MAP "B" PROPOSED ZONING
File Z17-0093

MEMORANDUM**Date:** October 31, 2017
File No.: Z17-0093**To:** Community Planning (AC)**From:** Development Engineering Manager (JK)**Subject:** 726 Clement Ave (REVISED) I4 to C4

Re: Submission of Revised Development Proposal Drawings for 726 Clement Ave., Kelowna

Project Number
16049
Scale
1/250
Sheet Number
A-002

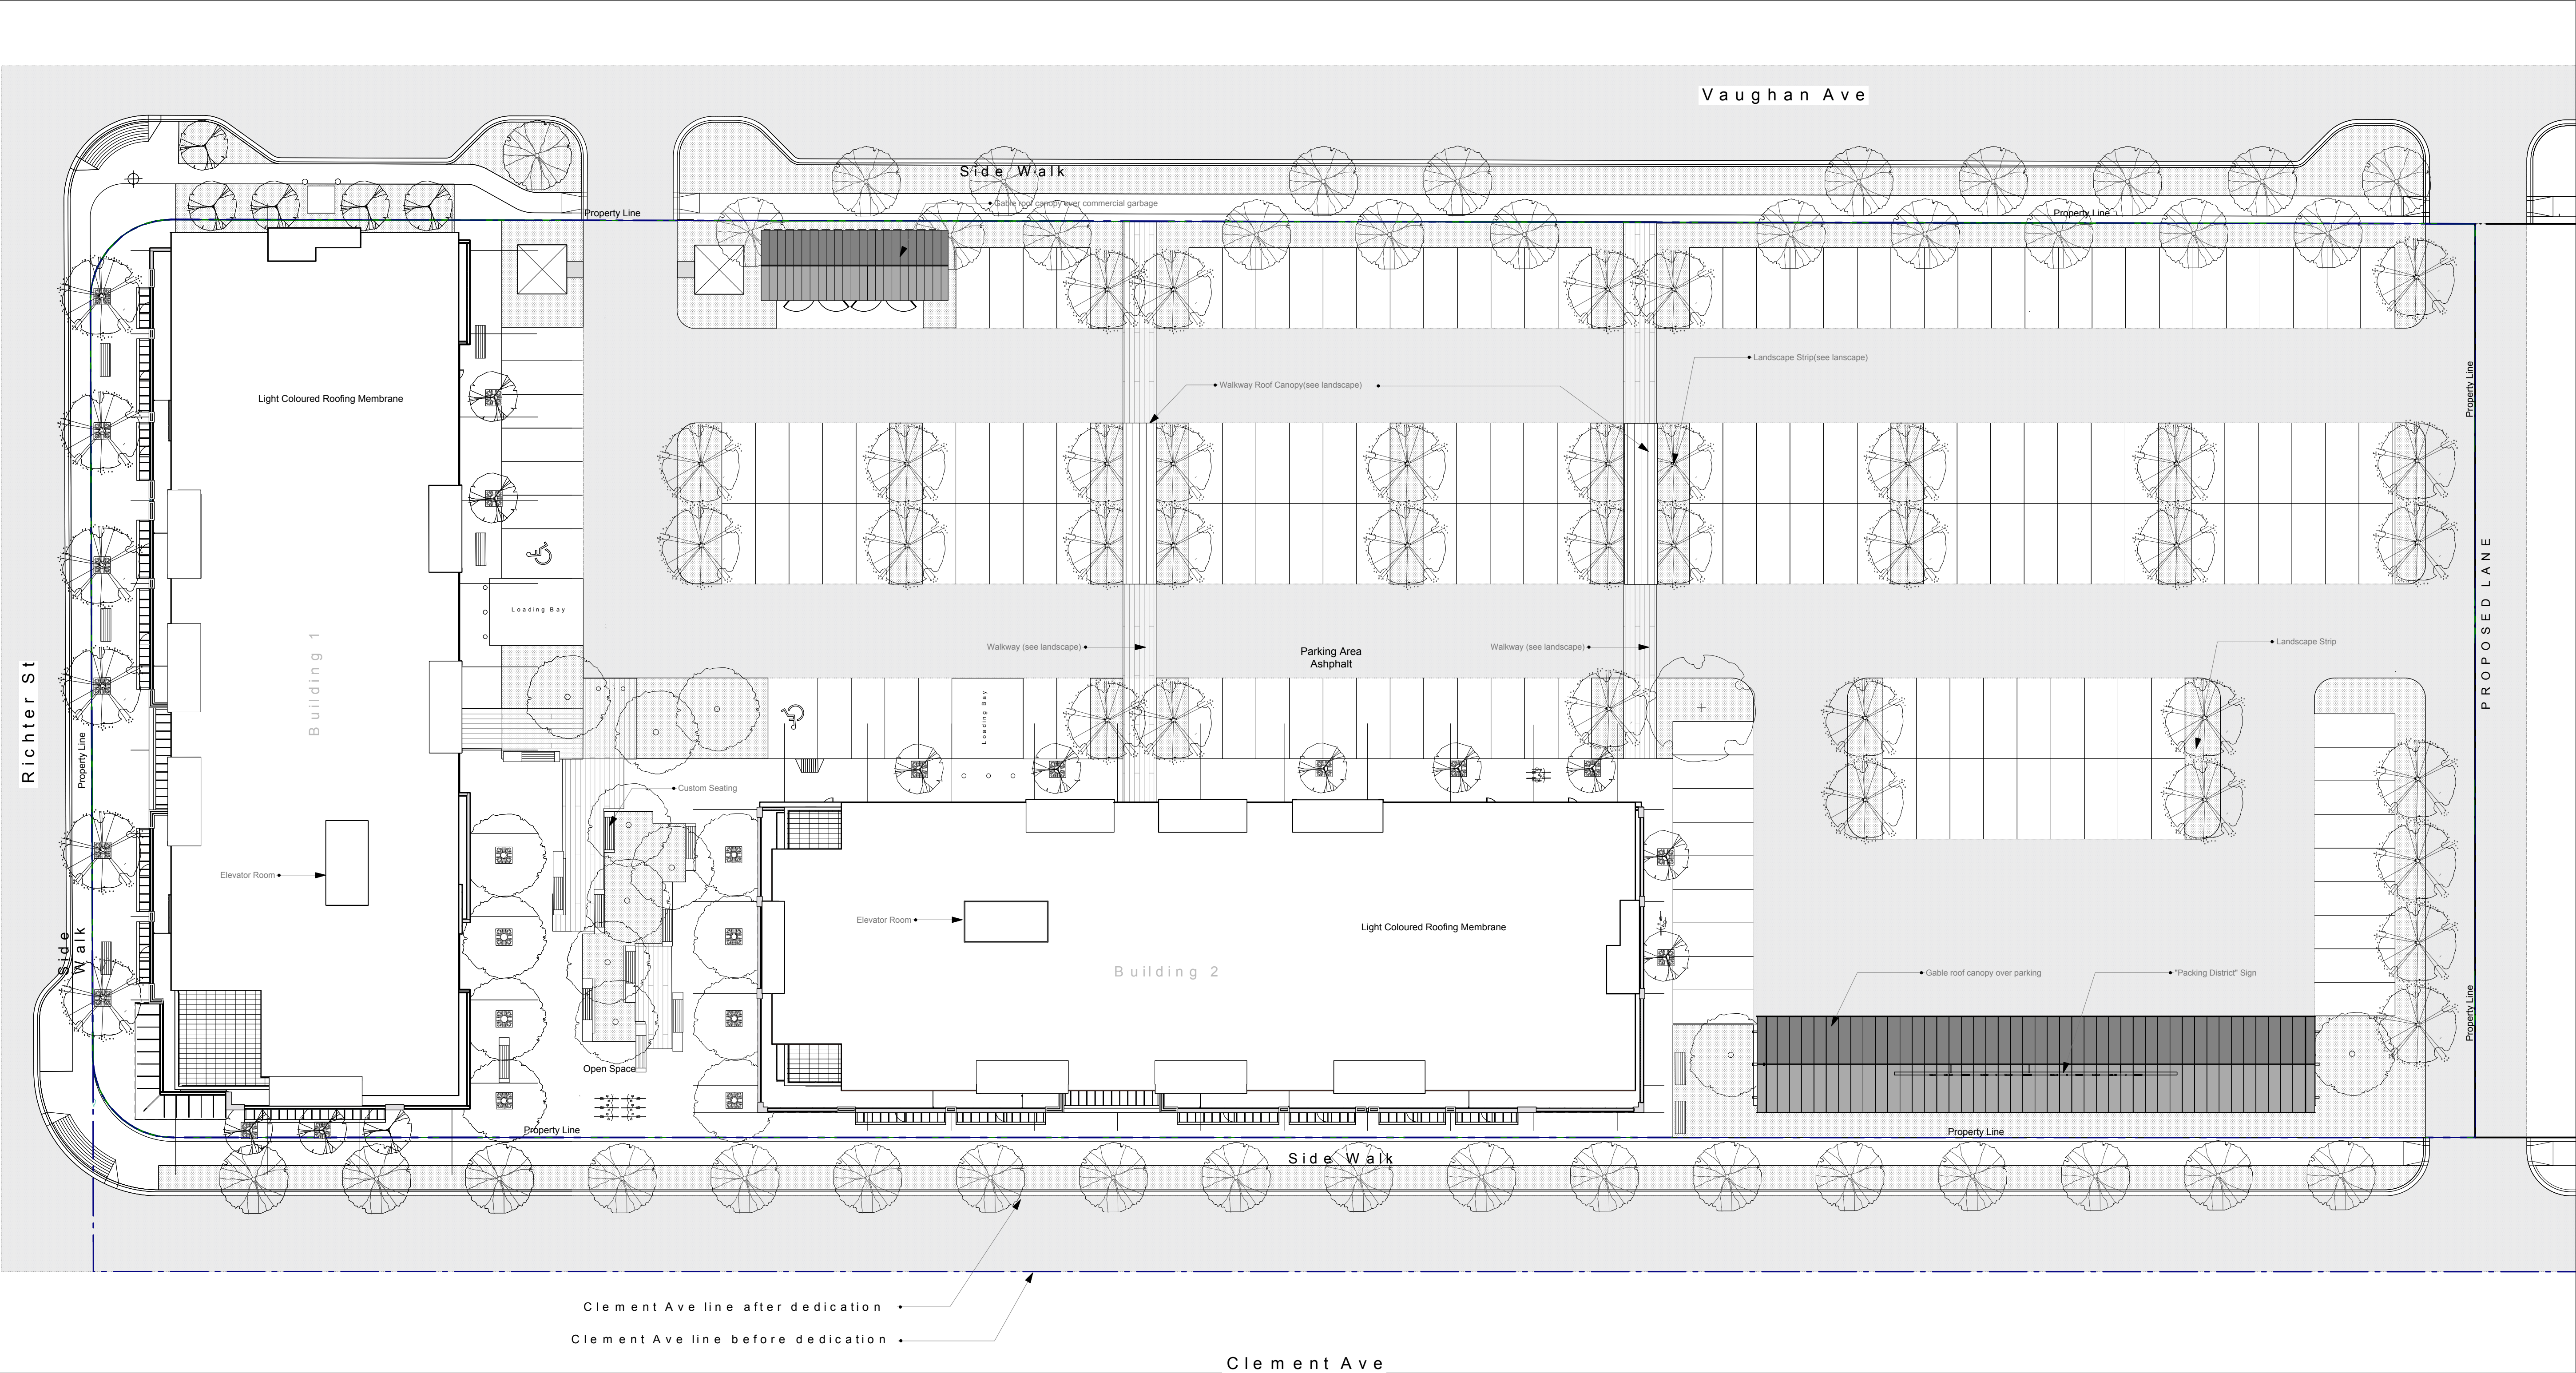
- 2) Vaughan is to have parallel parking only (no angled parking).

- 4) A major concern remains the amount of surface parking. We do not have any recent urban mixed used (commercial / residential) developments that have not provided structured parking of some kind. You are also over your parking count by approximately 15%. This is seen as a negative when providing surface parking as it increases the amount of impervious surfaces. Can you provide parking down to the bylaw minimum and create a green space?

Response: Drawings are revised to show parallel parking on Vaughan Avenue. Please see revised civil set page 9 and architectural A-002.

Response: We have reduced parking stalls by 16% from 231 to 194 as well as converted several stalls into landscaping islands. Amount of landscaping and trees along Vaughan Avenue has been increased as well.
